**Seattle
Design
Commission**

**APPROVED
MINUTES OF THE MEETING
3 July 2003**

3 Jul 2003 Project: **Harborview – Street and Alley Vacation**
Phase: Schematic Design and Public Benefits Package Follow-up
Previous Reviews: 19 April 2001 (Design Guidelines and Public Benefits Package), 1 March 2001 (Briefing), 16 March 2000 (Briefing), 2 March 2000 (Briefing), 16 December 1999 (Conceptual Briefing)
Presenters: Elise Chayet, Harborview
Rich Dallam, NBBJ
Chuck Kolb, NBBJ
Attendees: Beverly Barnett, SDOT
Joe Brogan, Foster Pepper
Midhat Delic, NBBJ
Jamie Fleming, NBBJ
Joel Matulys, UW - CPO
Carol Proud, DCLU
Maureen McCarry, Harborview
Allen Whitaker, NBBJ
Jerry Yin, NBBJ

Harborview view north on 9th Ave

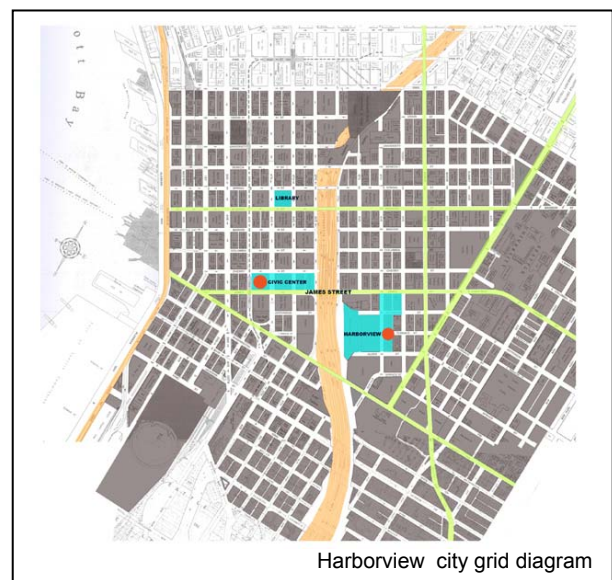
- Agrees with the increased transparency of the bridge and feels that it works well up close as it will incorporate color and motion. Would like the design team to consider the bridge as a landmark and as the terminus of an axis. Would like to know what the impact is from a distance. Feels that the south side where the skin of the building wraps around the corner onto the bridge is less effective in terminating the axis of the street.

- Would like to know what is on the underside of the bridge. Wonders if there are going to be utilities there.
 - Proponents stated that utilities will not be located on the underside of the bridge. They explained that they are treating this surface as another façade of the building.

- Proponents estimated that it is roughly 32-34 feet to the bottom of the bridge. They stated that it is their intention to keep the bottom of the bridge as high as possible above the street while accommodating the depth of the structure. The minimum height is 25 feet.

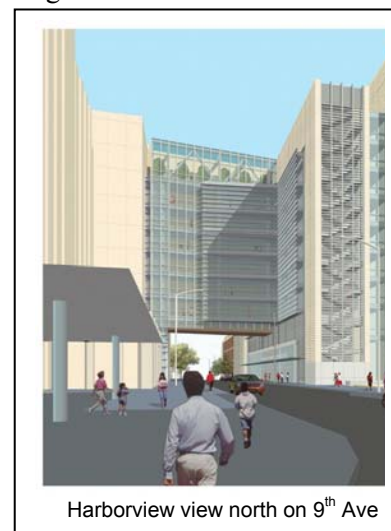
- Appreciates new bus shelter as the bus is the major form of transportation for many of Harborview's clients. Is concerned about the height of the canopy. Would like to know if the canopy is intended to

- Proponents stated that the height of the bus canopy has not yet been determined, but that it is intended to provide weather protection.
- Would like to know the height to the underside of the bridge and what the minimum allowable height is.

- Is concerned about the street level. Would like to know what the pedestrian connections are across the street. Would like to know if there are any new crosswalks. Feels it would be useful to see these on the drawings when talking about the street.

- Would like to know what the landscaping plan is. Wonders if trees will be in individual tree pits or in planting beds. Also notices that the trees are shown differently in different areas. Would like to know what this is indicating.

- Proponents stated that the first phase of the project will not generate a lot of public activity because of the use. They explained that the existing raised pavement in front of the main entrance will be maintained, as well as the existing crosswalks.

- Proponents stated that the details of the landscaping have not been determined, but that trees are not intended to be symmetrical on either side of the street. One side of the street will receive late afternoon light and the landscaping will respond to that. Proponents stated that they intend to have two staggered rows of trees on 9th Ave. in front of the 9th and James Building in order to create spaces for people to pause. They have not yet determined whether the trees will be between the sidewalk and the street or between the sidewalk and the building.
